Re: Initial Submission Review: The Aurora Highlands Lennar Phase 2 - Site Plan and Plat
Application Number: DA-2062-68
Case Numbers: 2025-3010-00, 2025-4005-00

Initial Submission Review

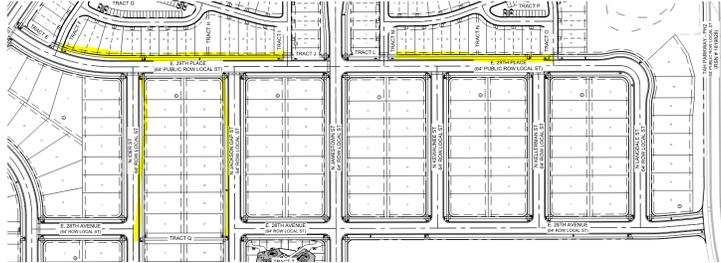
- 2O. There is an existing drainage easement that runs south of E. 32nd Avenue (see right) that is not shown on the site plan. The easement runs through some of the lots. Show the easement on the site plan, grading, and landscape sheets. Add a note, if applicable, that it is to be removed by a separate document. If it is to remain, revise the lots and landscape accordingly.
